3 PROBLEMS AND RECOMMENDATIONS

**Proposed Access Strategy
 Roundabout off Chalkstone Way**

Appendix B – Amended Design Drawing for Access

UNTIL TECHNICAL APPROVAL HAS BEEN OBTAINED FROM THE RELEVANT LOCAL AUTHORITIES, IT SHOULD BE UNDERSTOOD THAT ALL DRAWINGS ARE ISSUED AS PRELIMINARY AND NOT FOR CONSTRUCTION. SHOULD THE CONTRACTOR COMMENCE SITE WORK PRIOR TO APPROVAL BEING GIVEN, IT IS ENTIRELY AT HIS OWN RISK.

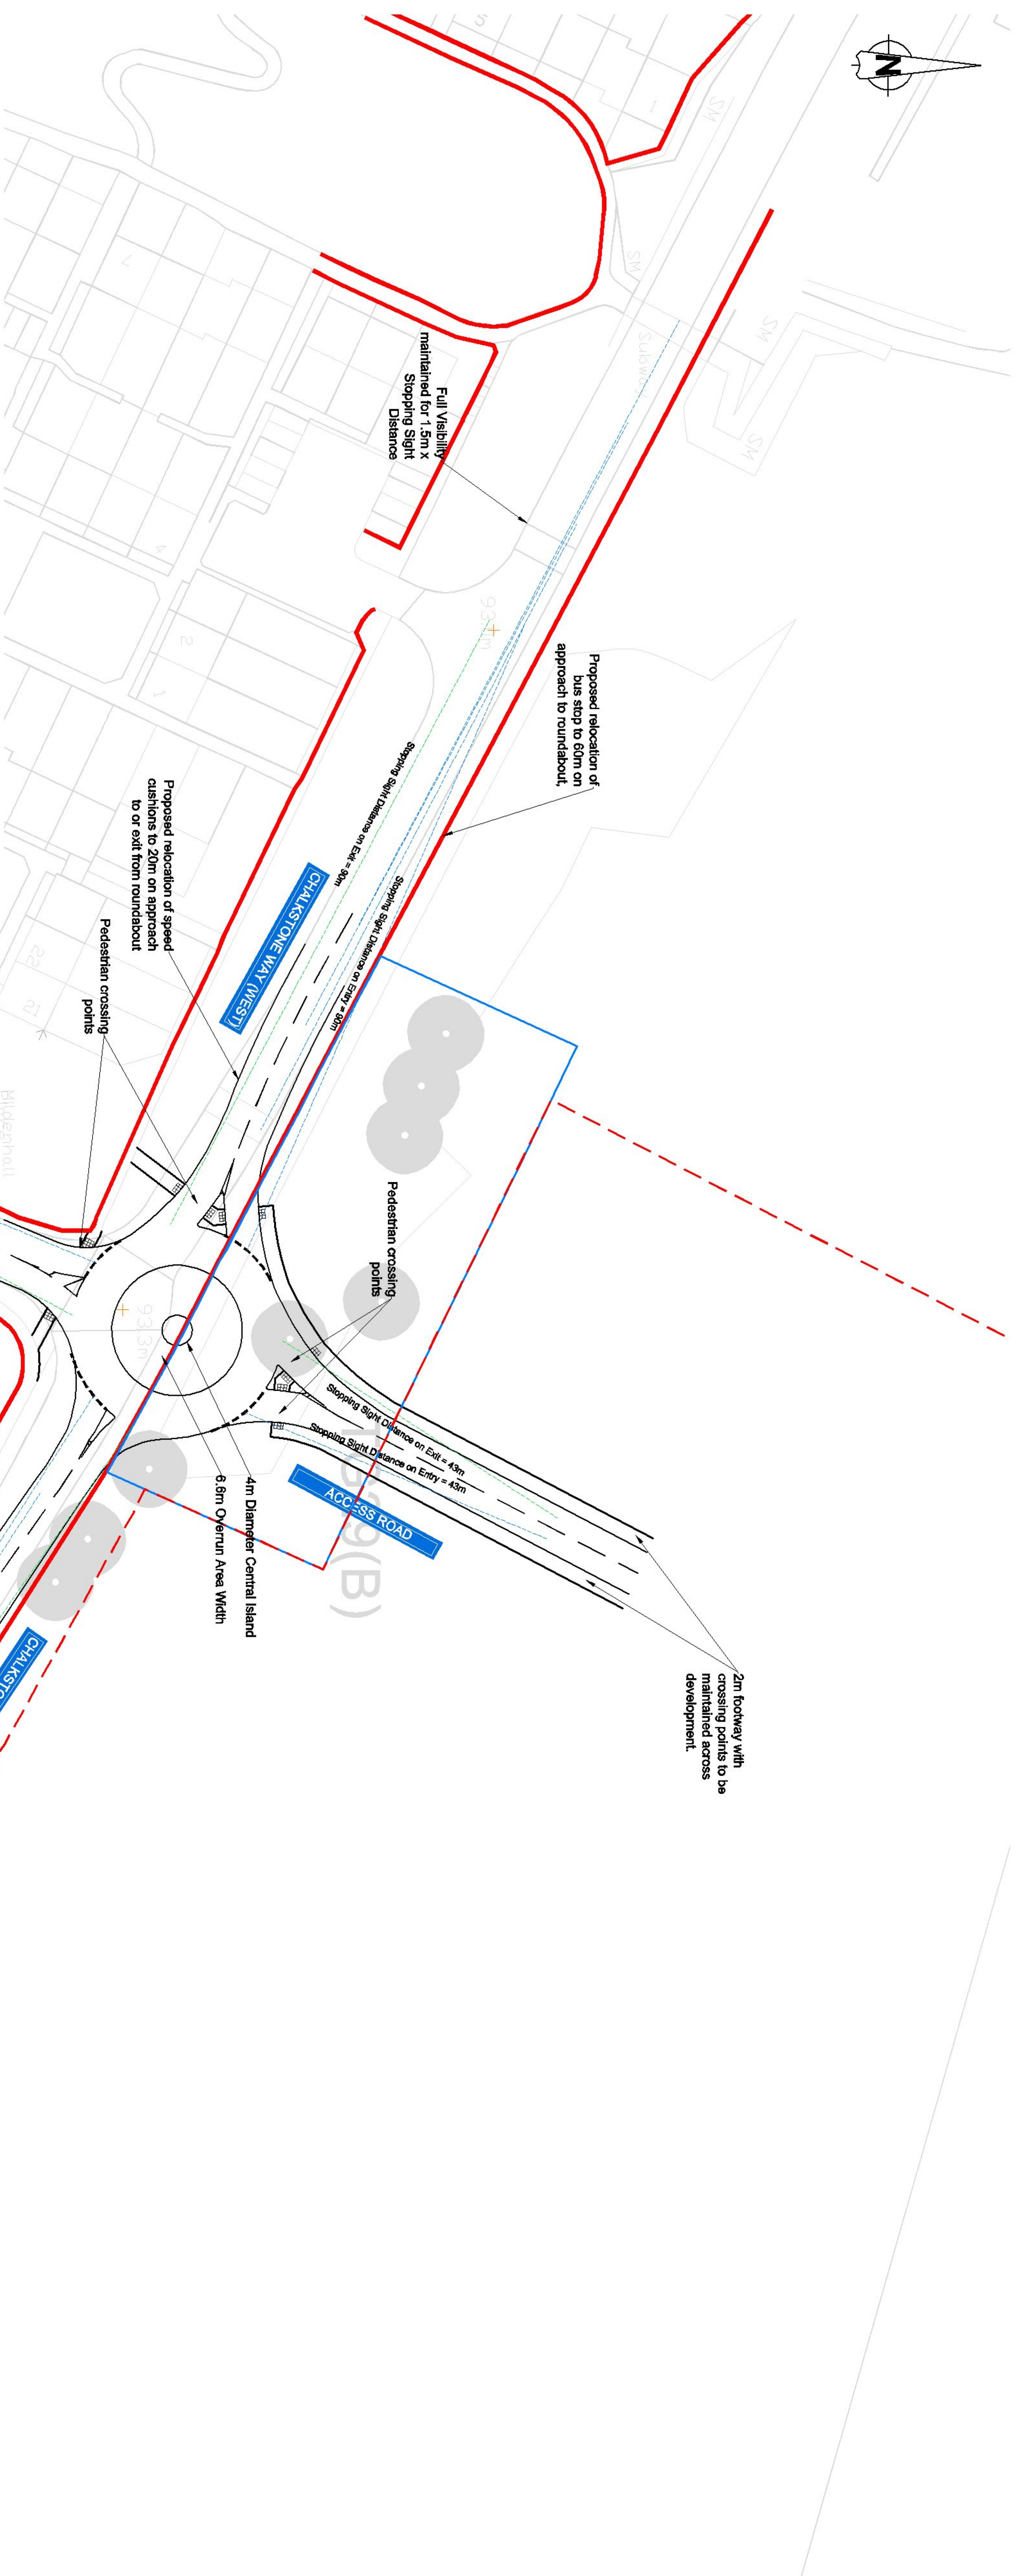
3.1 **Problem 1 : Inadequate deflection on vehicle paths**

Location: Eastern and northern arms approaches to the roundabout.

Summary: The design layout of the roundabout is such that there is potential for failure to give way on entry resulting in straight-ahead collisions with roadside furniture or side-impact or shunt type collisions.

- 3.1.1 For the roundabout entry from the east (Chalkstone Way) the entry path curvature is in the region of 140m and for the roundabout entry from the north the entry path curvature is in the region of 100m, both using the over-run area edge as the vehicle path guide. Such potential approach paths give inadequate entry path curvature to fully-prevent traffic from entering the roundabout at too high a speed or having to resort to late-braking (DMRB standard TD16 also refers).

- 3.1.2 The drawings do not show any traffic calming measures on the development Access Road.
- 3.1.3 Whilst the Auditors do acknowledge that Chalkstone Way is a traffic-calmed road the situation could be hazardous to cyclists, particularly in view of the wide overall circulatory carriageway width as associated with all compact roundabout layouts that are designed to accommodate specific large/long vehicle types, not all of which type might use the subject roundabout and approach roads.

3.2 **Problem 2 : NMUs**

Location: NMU paths to/from the development.

Summary: Inadequate provision of NMU facilities could lead to NMU conflicts and/or NMUs using non-designated routes or making crossings of roads at inadvisable locations with risks of slips, trips and falls injuries.

- 3.2.1 The footway from the development ends at the northwestern quadrant with pedestrians having to cross Chalkstone Way to gain access to the existing footway along the southern side of Chalkstone Way. Not far west of the proposed roundabout is the Westfield Primary Academy school so the Auditors would expect some NMU demand between the development (the Access Road roundabout) and the school which is not catered for in the current proposals unless such trips cross and re-cross Chalkstone Way.

3.3 **Problem 3 : Bus stop location**

Location: Chalkstone Way west of the roundabout.

Summary: Stationary buses blocking entry to the roundabout could cause risks of frustrated following vehicle drivers overtaking when unsighted and colliding with traffic exiting the roundabout or even driving the wrong way around the roundabout.

3.3.1 The existing bus stop west of the roundabout is located only approx. 25m ahead of the roundabout 'Give Way' line and the drawing has no indications of bus stop relocation.

3.4 **Problem 4 : Speed cushion feature**

Location: Chalkstone Way immediately west of the roundabout.

Summary: Proximity of feature to roundabout entry/exit would be a potential frustration to drivers causing potential rash decision-making or encourage pedestrians to cross the road where no formal crossings is intended and which could surprise drivers and lead to vehicle/pedestrian conflicts.

3.4.1 There is an existing speed cushion arrangement immediately west of the roundabout located only approx. 15m ahead of the roundabout 'Give Way' line and the drawing has no indications of its removal. With a roundabout so close the speed cushion arrangement would appear superfluous and could safely be removed – however, 'Problem 1' relates in respect of speed control on the roundabout approaches.

- 3.1.4 The recommendations are that :
- The roundabout should be re-designed to ensure that vehicle entry paths have radii tighter than 70m radius (such re-design might involve the provision of a larger roundabout) ; and

- Traffic calming should be applied to the development Access Road.

- 3.2.3 The recommendation is that :
- The footway along the western side of the development Access Road should be continued on to the school entrance not far west of the proposed roundabout with, perhaps, enhancement to shared cyclist/pedestrian status.

3.3.2 The recommendation is that :

- The bus stop should be relocated further west, sufficiently away from the roundabout.

- The speed cushion arrangement should be relocated a short distance further west.
